### ADDENDUM NO. 1 - OUTLINE AND SUMMARY INFORMATION

Project Name: MSU Stadium Lots

PPA No.: 22-0012

Date: 03-27-2024

**1 SITE PLAN AREA 1**  
EP2.1 1" = 20'-0"

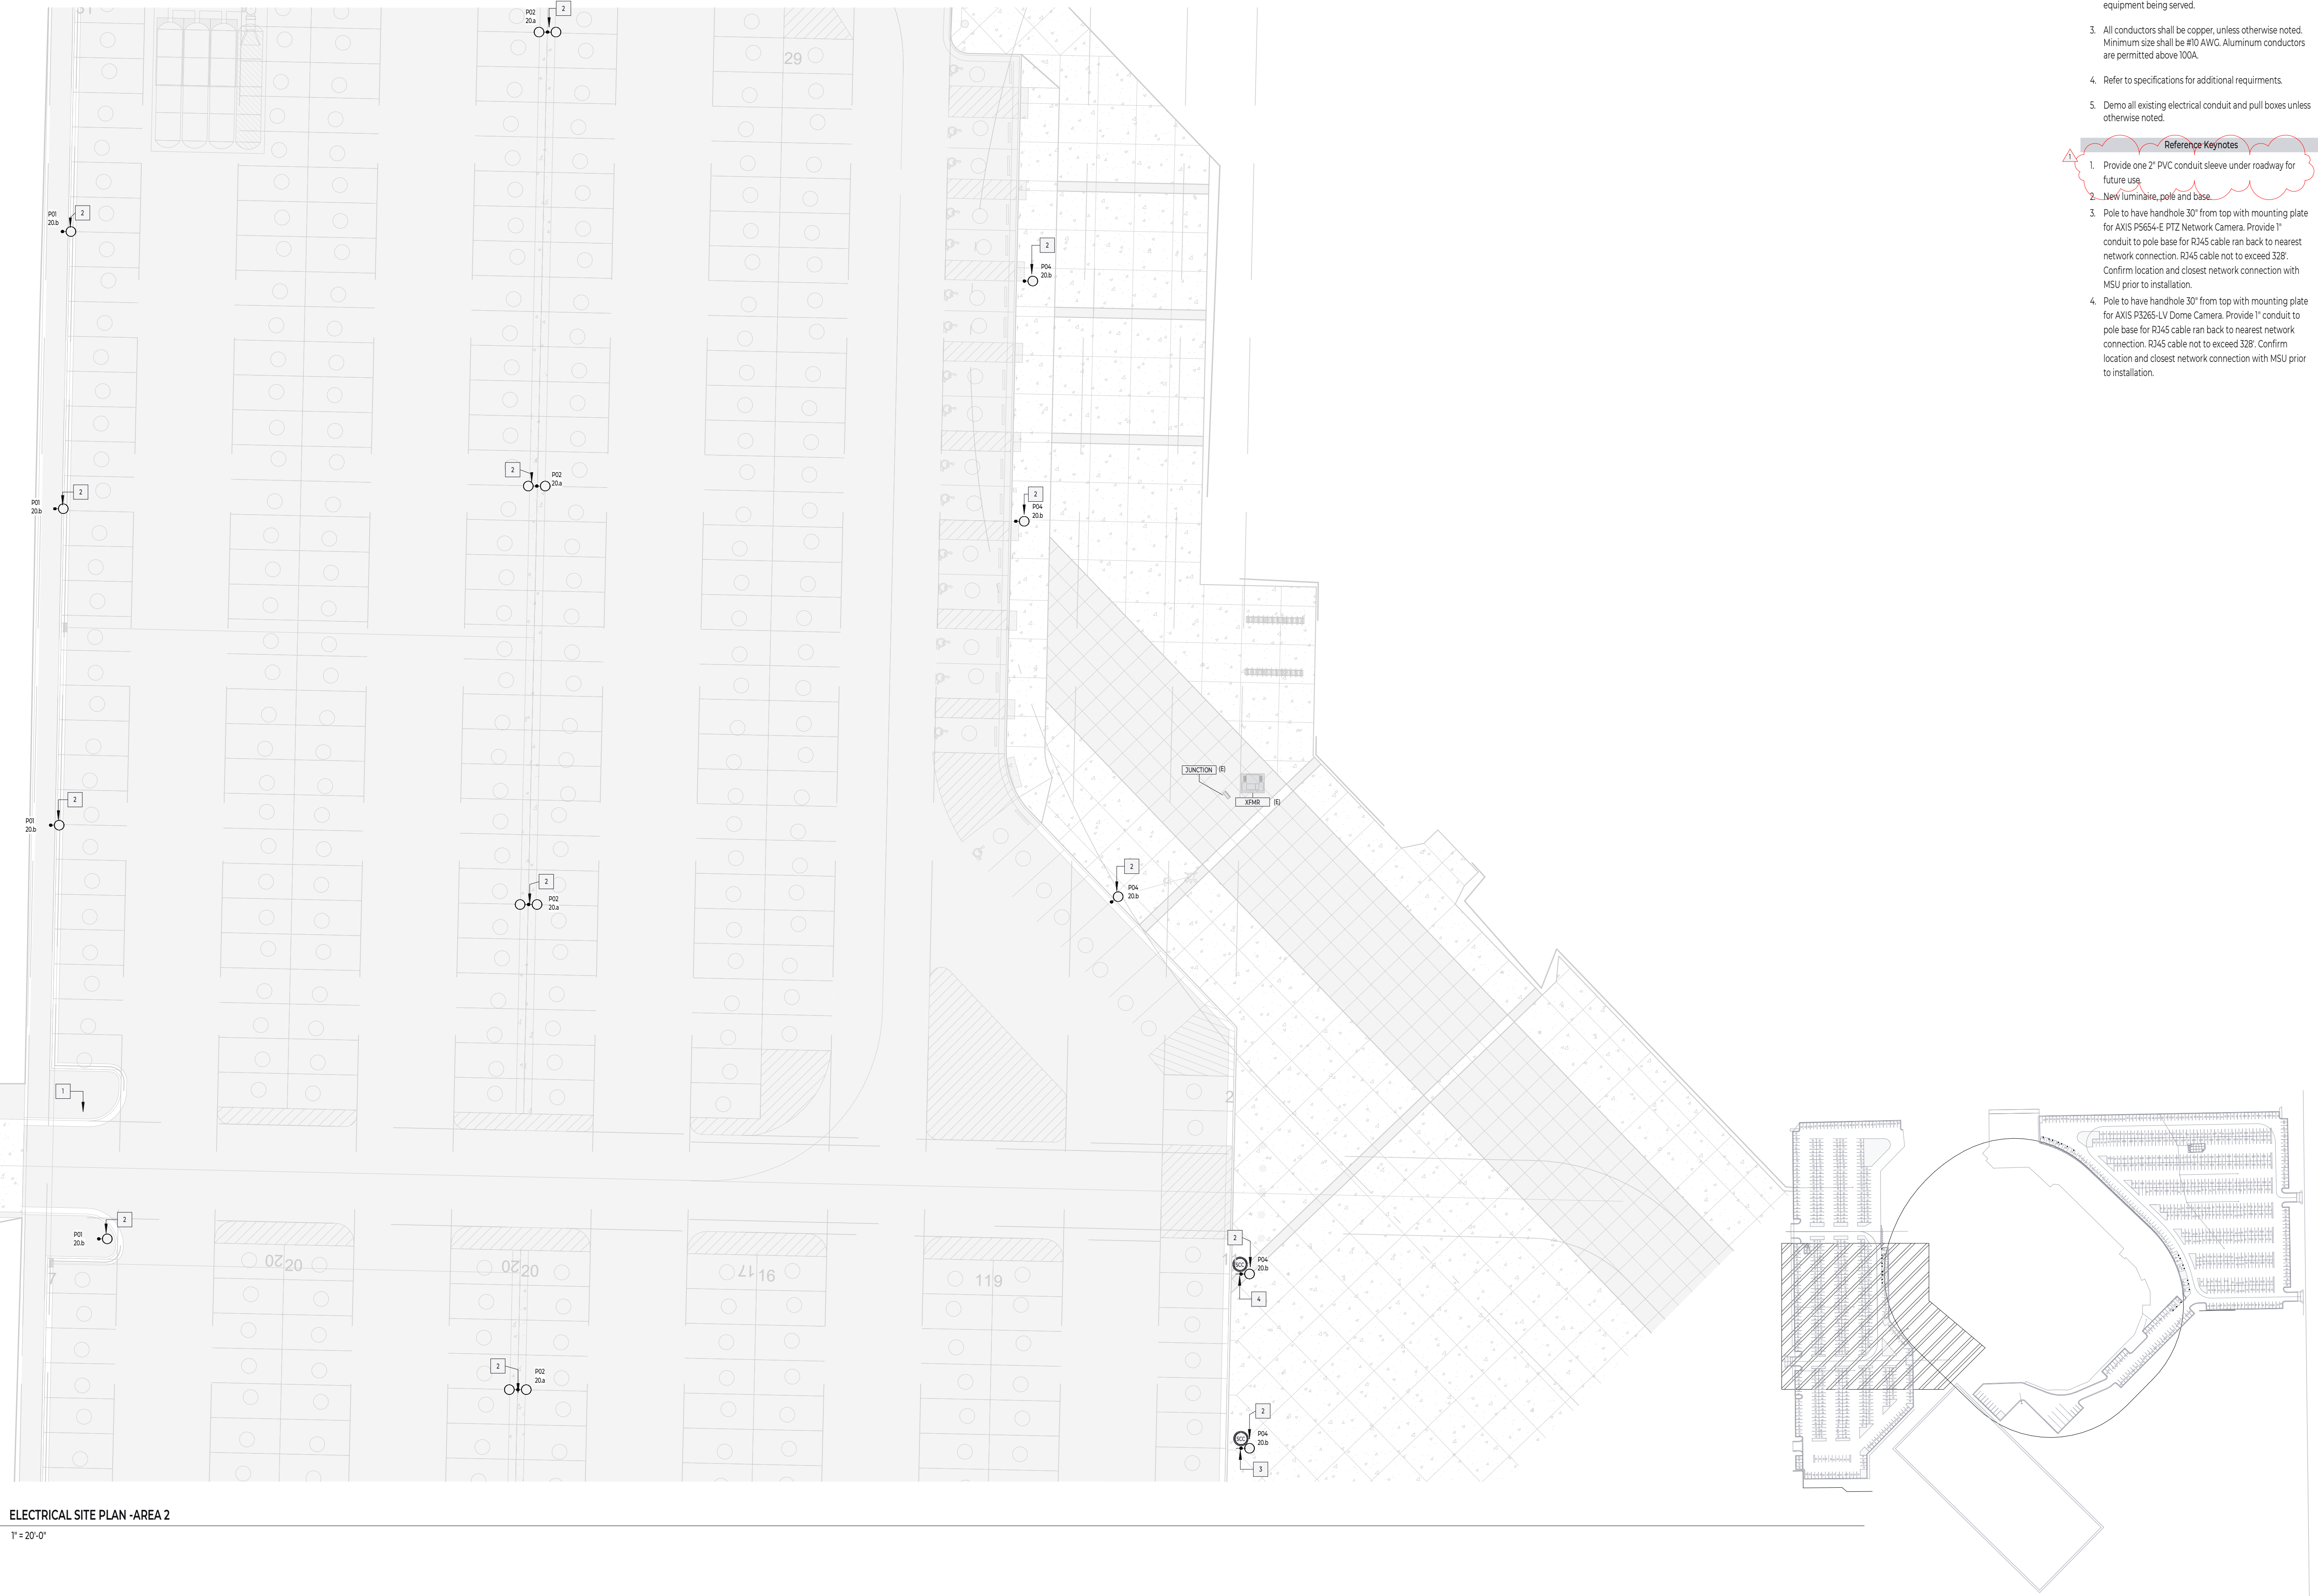
- A. REVISE – Revisions to sheet note 3.

1. New luminaire, pole and base.
2. Provide 2" conduit under sidewalk for future use.
3. Provide one 2" PVC conduit sleeve under roadway for future use.

1 ELECTRICAL SITE PLAN - AREA 2  
EP2.2 1" = 20'-0"

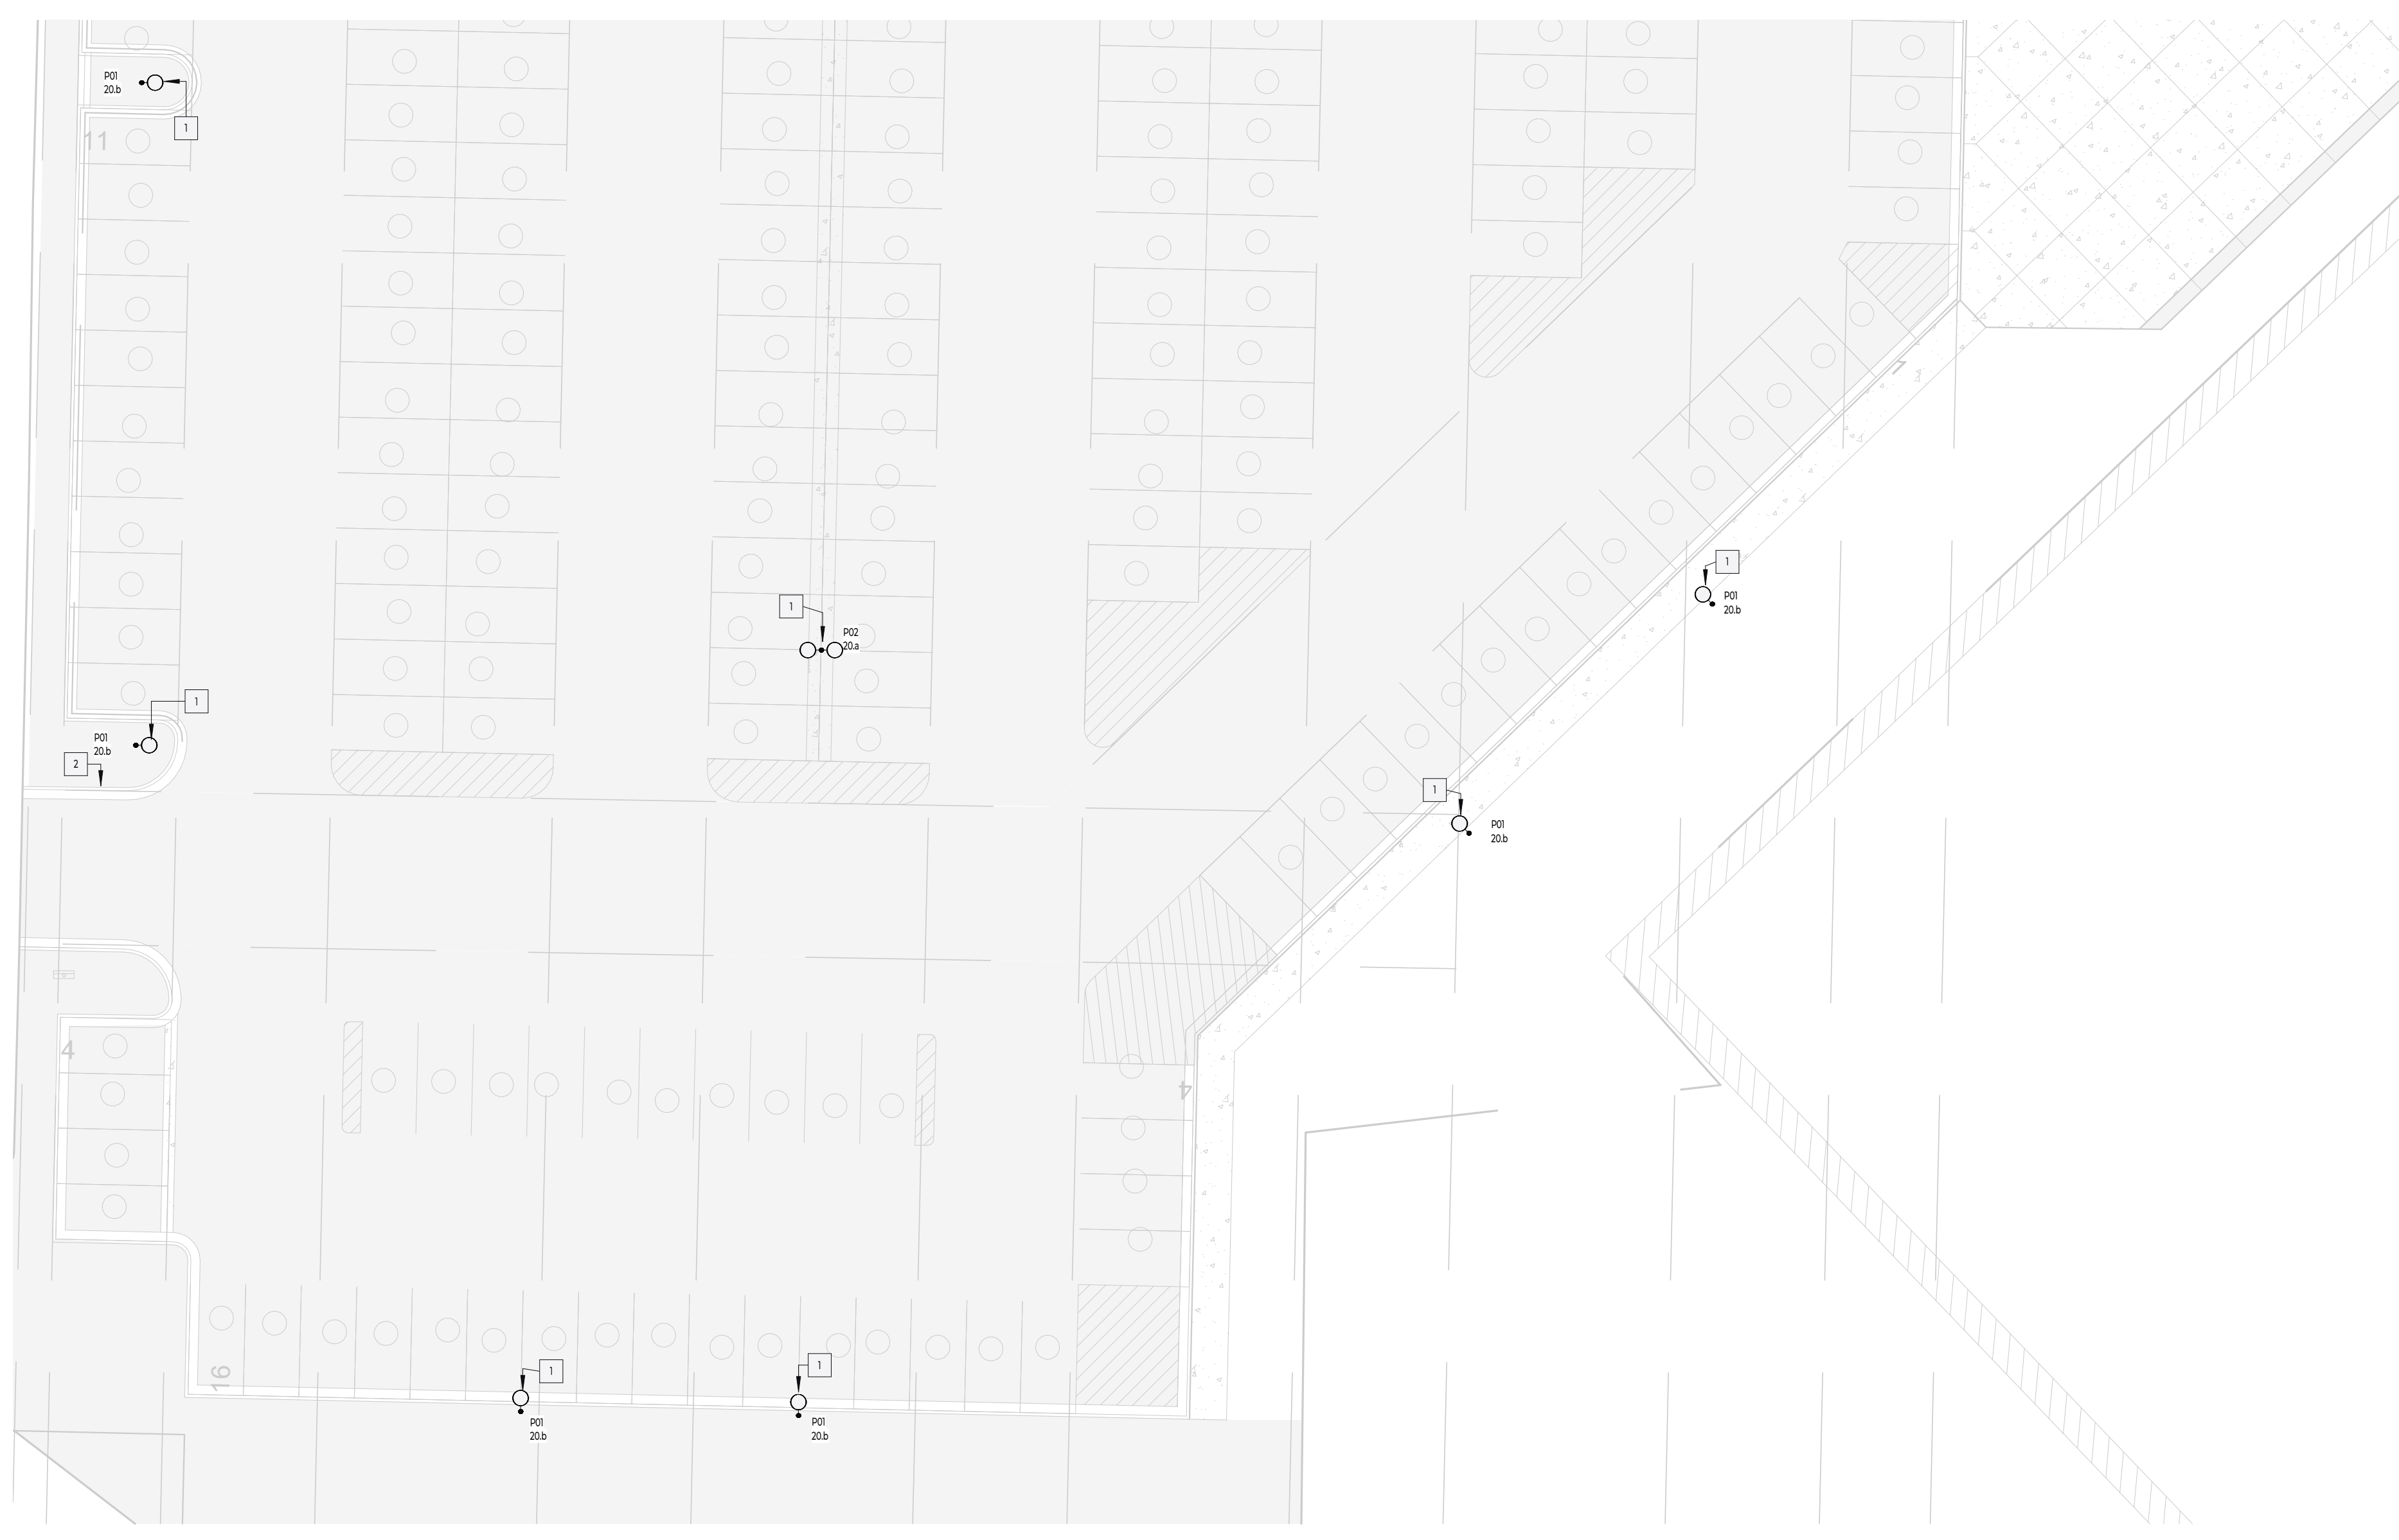
- A. REVISE – Revisions to sheet note 1.
